10530.0000
Southpoint Ridge
15-mth & 2-yr Warranty Review

Regarding: **15-mth & 2-yr Warranty Review**

Method Engineering and Building Services Ltd. (METHOD) was retained by Strata Plan EPS 5294 to complete a review related to the 15-month and 2-year warranty at phase 1-3 of the Southpoint Ridge Townhouses in Langford, BC.

OBS A01-01

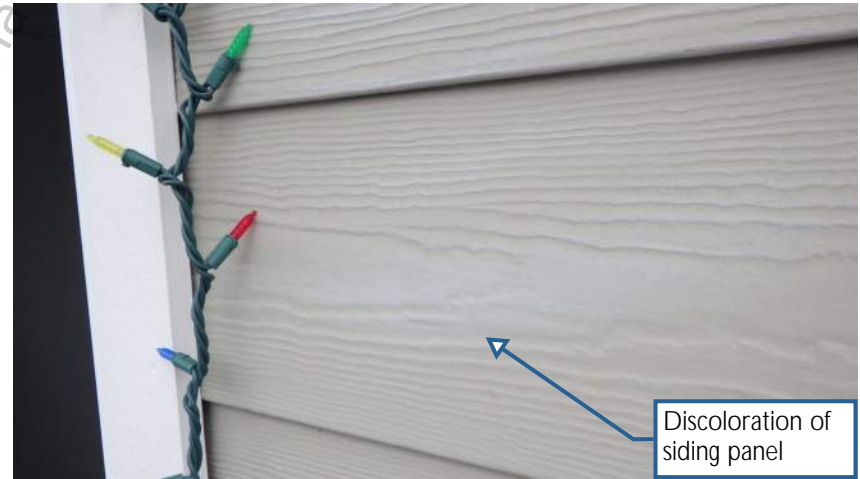
Item ID	Location	Policy Number	Photo Sequence	Observations
A01 - A	Unit 1223 Balcony	80250933	OBS A01-01 to OBS A01-02	<ul style="list-style-type: none"> Balcony overhangs the common property road and has been hit by vehicles on several occasions. This condition has caused damage to balcony guardrails and presents the risk of damage to the balcony structure. Photo OBS A01-02 illustrates the extent that the balcony overhangs the road below. This condition is not a building code issue. It is however, a safety concern. We recommend modifications are considered and implemented to eliminate future risk.
A02 - A	Unit 1223	80250933	OBS A02-01	<ul style="list-style-type: none"> Inconsistent paint finish at metal flashing. This is a cosmetic workmanship item and not a performance concern.
A03 - A	Unit 1223	80250933	OBS A03-01 to OBS A03-02	<ul style="list-style-type: none"> Surface damage or discolouration on pre-finished cement board siding. This is a cosmetic workmanship item and not a performance concern.

OBS A05-01

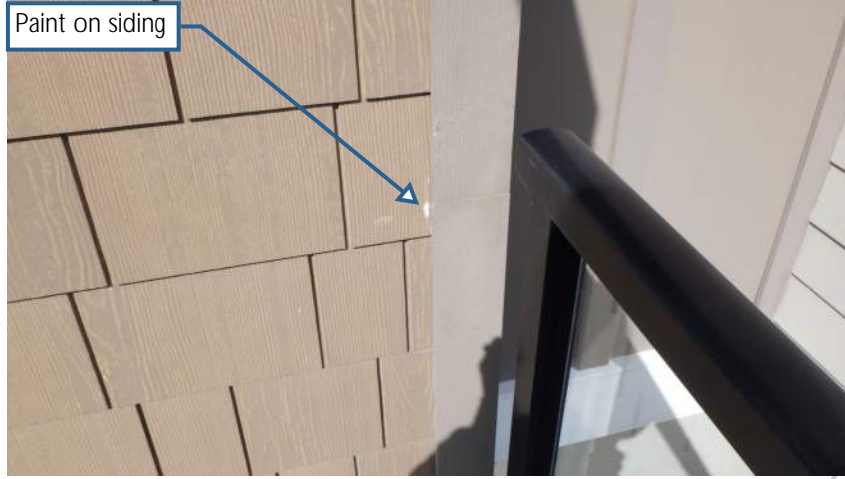
Trim paint on siding

Paint on siding

OBS A16-01

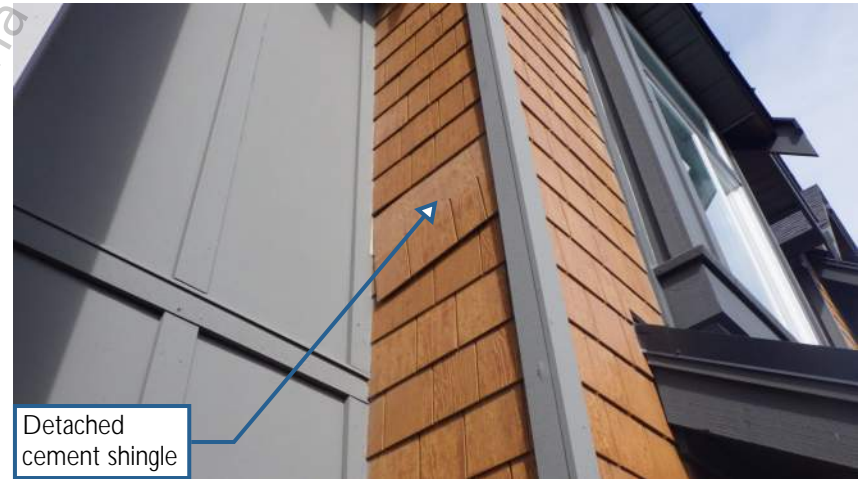
A14 - B	Unit 1233, 1237	80250968	OBS A14-01 to OBS A14-04	<ul style="list-style-type: none"> Unpainted fastener at siding. This is a cosmetic item and not a performance concern.
A14 - E	Unit 1257	80252839		
A15 -				Item number omitted
A16 - C	Unit 1241	80250963	OBS A16-01 to OBS A16-06	<ul style="list-style-type: none"> Sections of cement board siding are detached. At unit 1253, a section of shingle siding is not installed flush creating a void in the cladding.
A16 - D	Unit 1251, 1253	80252844		
A16 - B	Unit 1235	80250968		
A17 - C	Unit 1241	80250963	OBS A17-01	<ul style="list-style-type: none"> Noted a void between the vinyl waterproofing membrane and the wall cladding at the balcony saddle. At other balconies, sealant is installed at this location to eliminate the void.

OBS A16-05

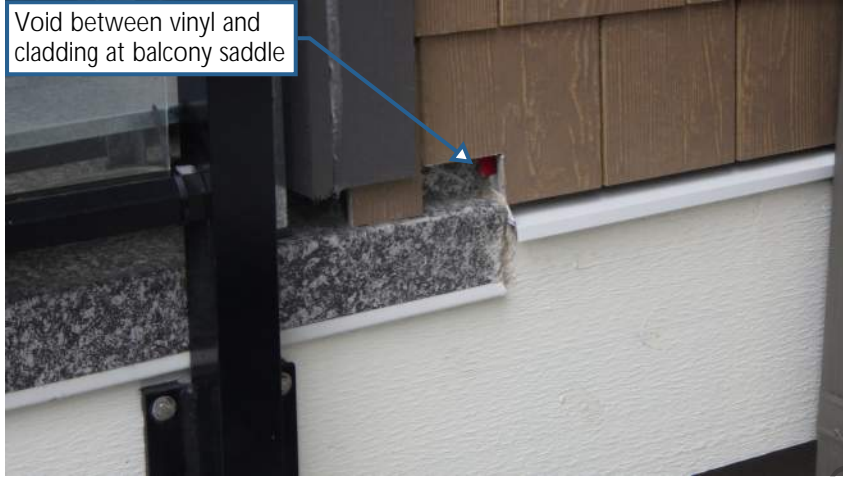
Siding was not installed flush with the other siding

Siding board was not installed flush with the other siding

OBS A20-04

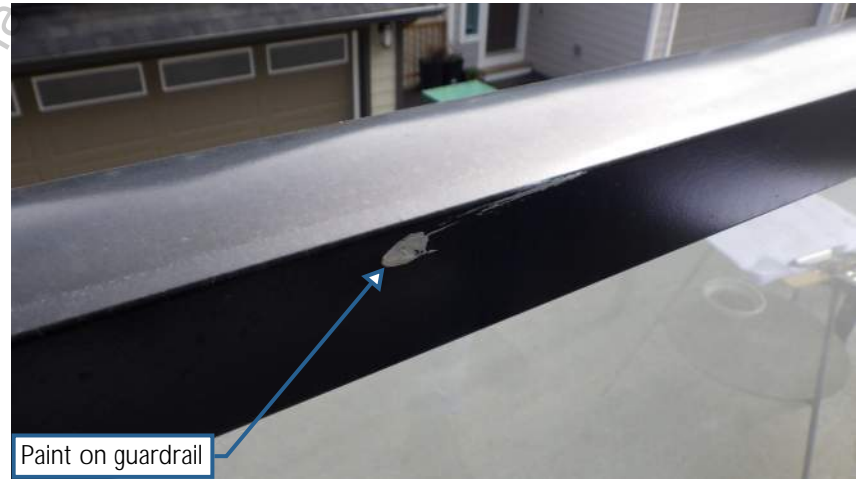
Crumpled soffit at sloped roof overhang

Crumpled soffit at sloped roof overhang

OBS A22-02

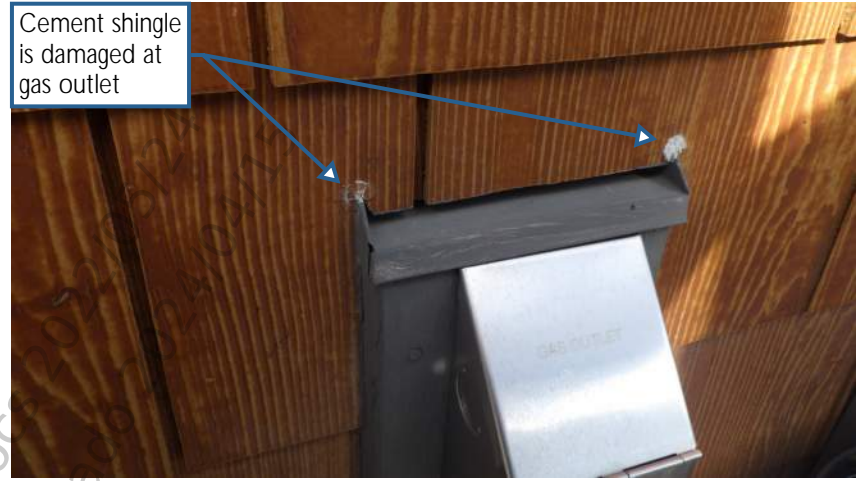
A21 -				Item number omitted
A22 - C	Unit 1245, 1243	80250963	OBS A22-01 to OBS A22-03	<ul style="list-style-type: none"> Paint on guardrail. This is a cosmetic workmanship item and not a performance concern.
A23 - D	Unit 1249	80252844	OBS A23-01 to OBS A23-03	<ul style="list-style-type: none"> Cement board shingle siding is damaged at the gas outlet head flashing resulting in a poor aesthetic finish. This is not a performance issue.
A24 - D	Unit 1249	80252844	OBS A24-01	<ul style="list-style-type: none"> Soffit panel is loose.
A25 - D	Unit 1251	80252844	OBS A25-01 to OBS A25-11	<ul style="list-style-type: none"> Exposed sheathing paper and tuck-tape at the base of cladding. This is a cosmetic/workmanship issue and not related to building performance.
A25 - F	Unit 1220, 1216, 1224, 1228	80267576		
A25 - E	Unit 1261	80252839		
A26 - D	Unit 1253	80252844	OBS A26-01 to OBS A26-02	<ul style="list-style-type: none"> Paint on door. This is a cosmetic workmanship item and not a performance concern.

Paint on guardrail

OBS A23-01

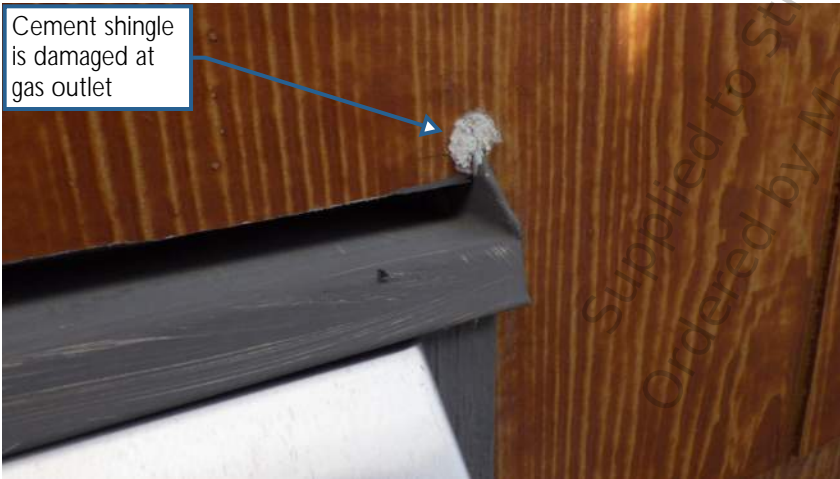
Cement shingle is damaged at gas outlet

Cement shingle is damaged at gas outlet

Cement shingle is damaged at gas outlet

OBS A25-01

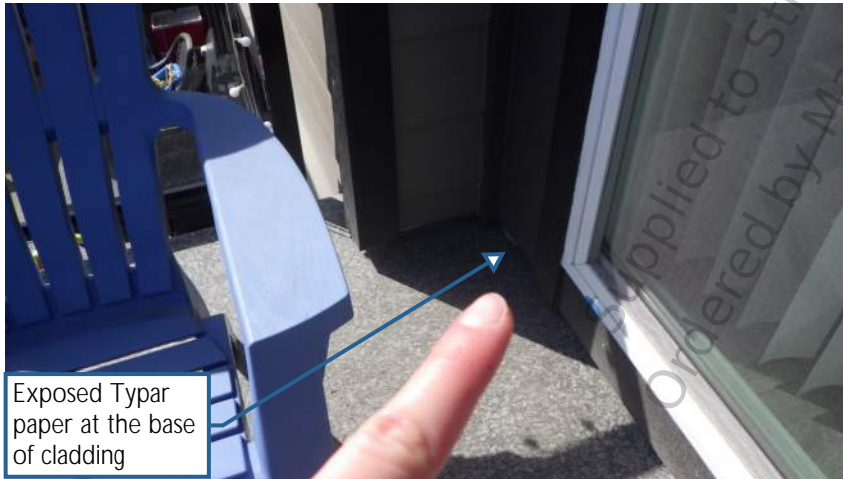
Exposed building paper at the base of cladding above front door

Exposed Tybar paper at the base of cladding

OBS A27-01

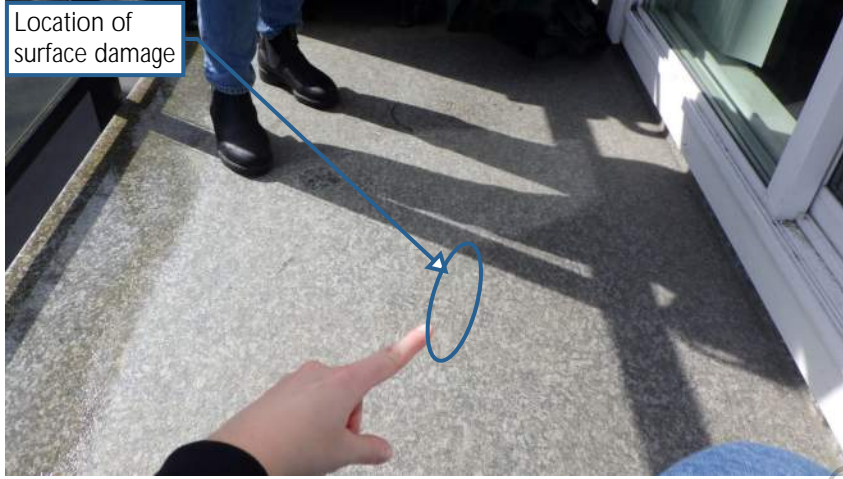
A27 - E	Unit 1257	80252839	OBS A27-01 to OBS A27-02	<ul style="list-style-type: none"> Discoloured sealant at door frame/window frame. This is a cosmetic/workmanship issue and not related to building performance.
A27 - F	Unit 1220	80267576		
A27 - A	Unit 1223, 1225, 1227	80250933		
A27 - B	Unit 1233	80250968		
A27 - C	Unit 1243	80250963		
A28 - E	Unit 1257	80252839	OBS A28-01 to OBS A28-04	<ul style="list-style-type: none"> Surface damage to vinyl waterproofing membrane. The damage is limited to the surface finish and does not affect the waterproofing. Recommend this area is reviewed annually.
A28 - F	Unit 1216	80267576		
A29 -				Item Omitted
A30 - F	Unit 1216, 1220, 1224, 1228	80267576	OBS A30-01 to OBS A30-05	<ul style="list-style-type: none"> Noted sections of unperforated soffit panels. This condition does not allow for soffit venting and provides inconsistent finish.
A31 - F	Unit 1216, 1220, 1224, 1228	80267576	OBS A31-01 to OBS A31-05	<ul style="list-style-type: none"> Missing diverter at balcony saddle allowing water to be directed behind the cladding at this location. At this location, the cross-cavity flashing butts up to the vinyl membrane and does not tuck underneath. This is not a building code defect but the installation of diverters is a preferred building method and a Travelers insurance requirement.

Discolored sealant at window frame

Discolored sealant at window frame

OBS A30-04

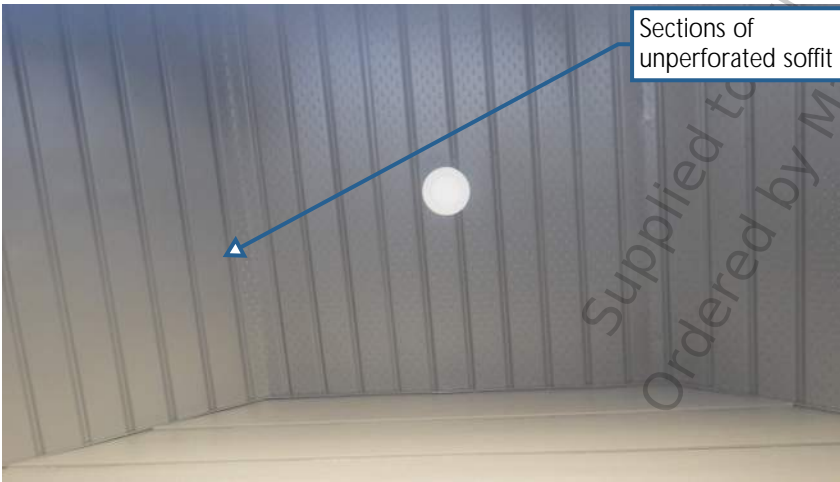
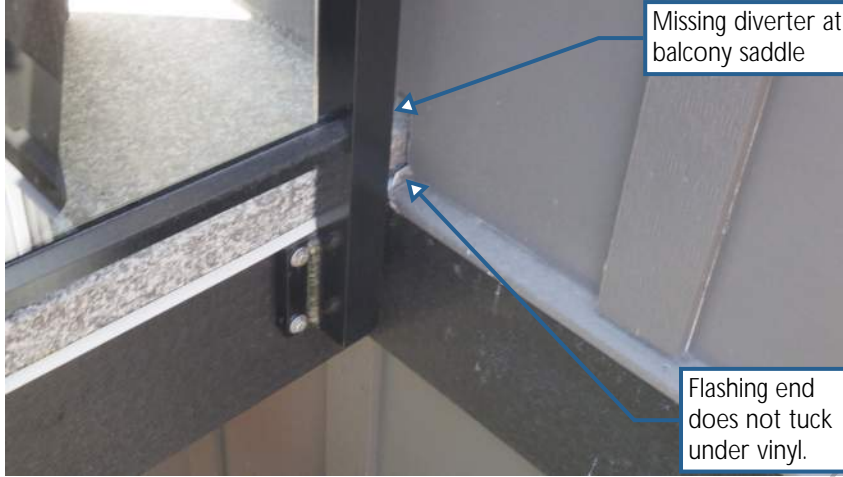
Sections of unperforated soffit

Sections of unperforated soffit

OBS A32-01

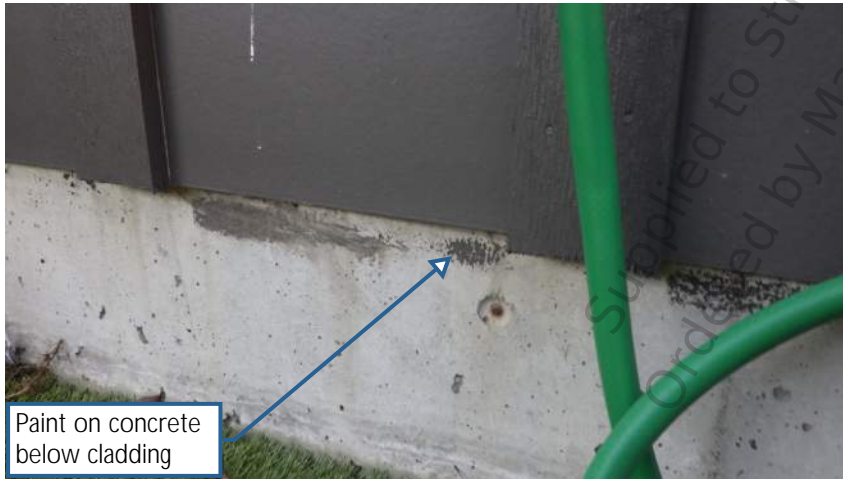
A32 - F	Unit 1224	80267576	OBS A32-01 to OBS A32-02	<ul style="list-style-type: none"> Paint on concrete below cladding. This is a cosmetic workmanship item and not a performance concern.
A33 - F	Unit 1224, 1228	80267576	OBS A33-01 to OBS A33-05	<ul style="list-style-type: none"> Dent noted in soffit panel. This is a cosmetic/workmansip issue and not related to building performance.
A34 - F	Unit 1224, 1228	80267576	OBS A34-01 to OBS A34-04	<ul style="list-style-type: none"> Efflorescence along base of concrete wall
A35 - F	Unit 1228, 1224	80267576	OBS A35-01	<ul style="list-style-type: none"> Construction debris noted on balcony fascia of unit 1228 Construction debris noted on the cladding of units 1224, 1228, and on the window at unit 1247 This is a housekeeping issue from the original construction work that was not addressed.
A35 - D	Unit 1247	80252844		
A36 -				Item Omitted
A37 - F	Unit 1220	80267576	OBS A37-01 to OBS A37-03	<ul style="list-style-type: none"> Corrosion staining noted on vinyl membrane. Occupant reported staining was present at first occupancy.

Paint on concrete below cladding

Paint on concrete below cladding

OBS A40-04

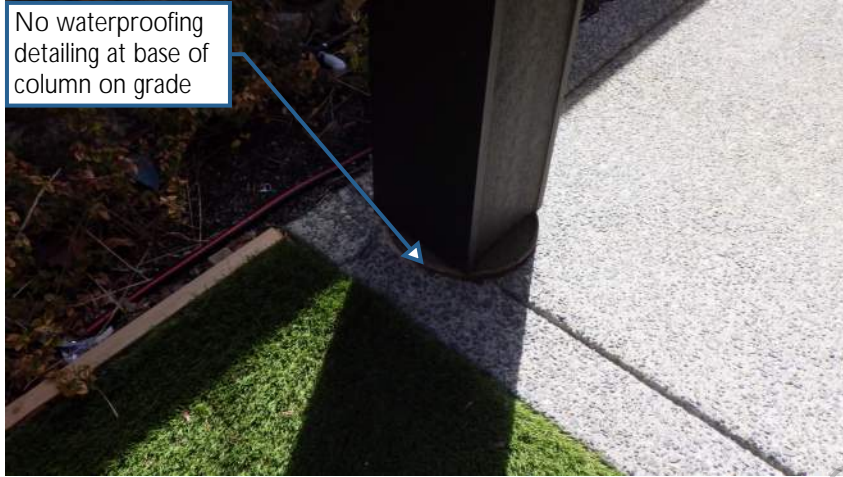
A38 -				Item Omitted
A39 -				Item Omitted
A40 - F	Unit 1220, 1216, 1228	80267576	OBS A40-01 to OBS A40-04	<ul style="list-style-type: none"> Missing sealant between window frame and trim at window jambs.
A40 - B	Unit 1237	80250968

Missing sealant at window frame

OBS A41-03

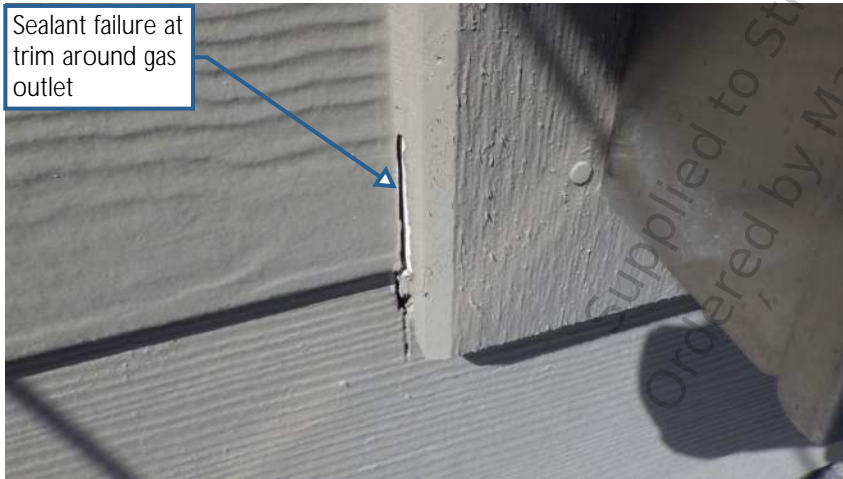
Item ID	Location	Policy Number	Photo Sequence	Observations
A41 - F	Unit 1220	80267576	OBS A41-01 to OBS A41-03	<ul style="list-style-type: none"> Balcony columns include sonotube concrete footings. No waterproofing has been installed at the footing and sonotube is exposed. Waterproofing may not be required if the column is installed on a stand-off saddle. It is recommended this is reviewed further to confirm. The remaining sonotube form is a housekeeping issue not removed during the original construction.
A42 - F	Unit 1216	80267576	OBS A42-01 to OBS A42-04	<ul style="list-style-type: none"> Sealant failure at trim around electrical and gas outlets and light fixtures.
A43 - F	Unit 1216	80267576	OBS A43-01 to OBS A43-04	<ul style="list-style-type: none"> Damage to cladding panel.
A43 - A	Unit 1227	80250933		
A44 - F	Unit 1216	80267576	OBS A44-01 to OBS A44-02	<ul style="list-style-type: none"> An exterior stairway is installed adjacent to Unit 1216 and does not include a railing. The stairway is blocked at the top but is accessible from below. This condition presents a fall hazard. We have advised the Strata to barricade the bottom of the stairs to prevent use until a guardrail is installed.

No waterproofing detailing at base of column on grade

OBS A42-01

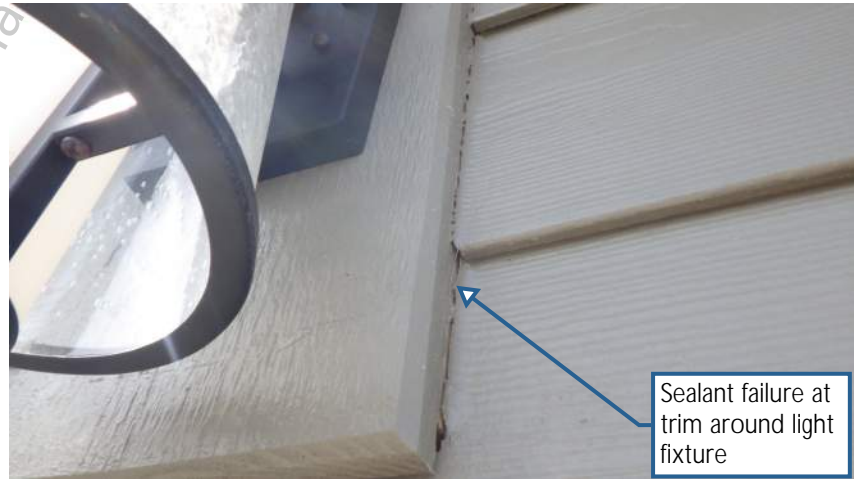
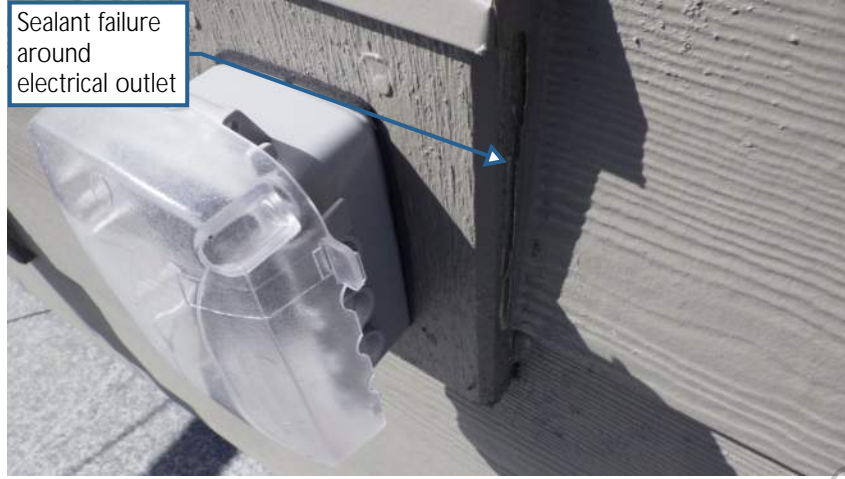
Sealant failure at trim around gas outlet

Sealant failure at trim around light fixture

OBS A47-01

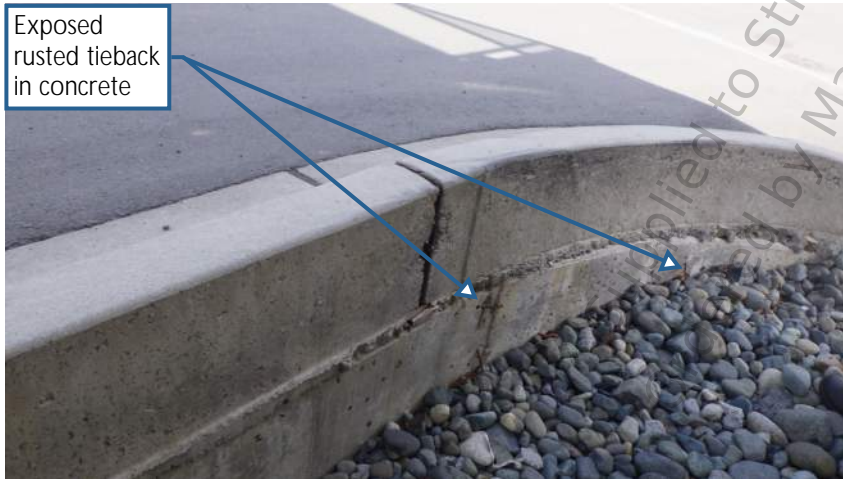
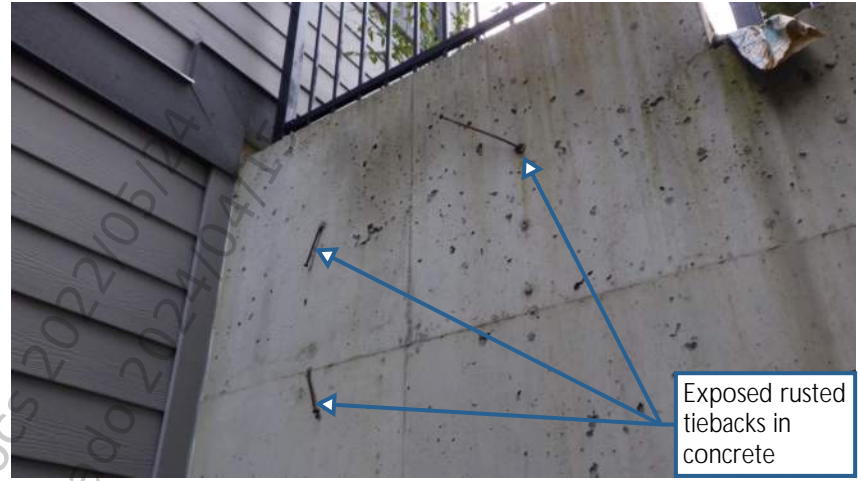
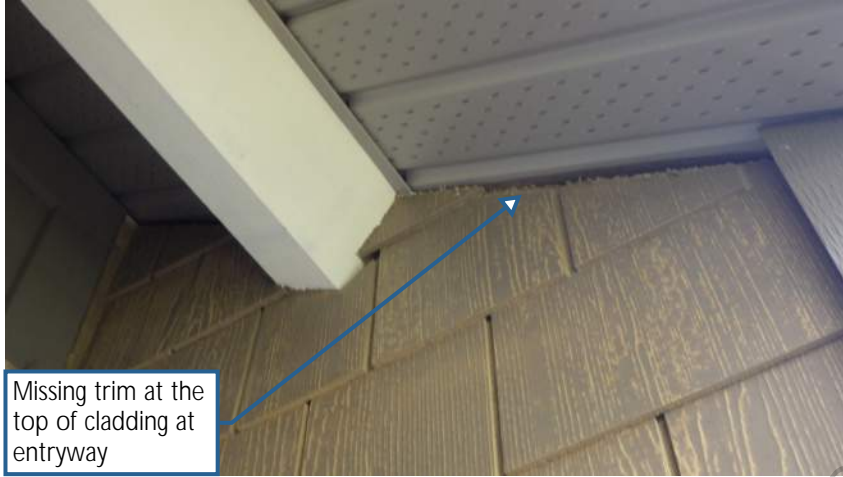
Exposed tieback/nail in concrete

Exposed rusted tieback in concrete

Exposed rusted tieback in concrete

Exposed tieback/nail in concrete

Exposed tieback/nail in concrete

Exposed rusted tiebacks in concrete

Exposed tieback in concrete

Exposed tieback/nail in concrete
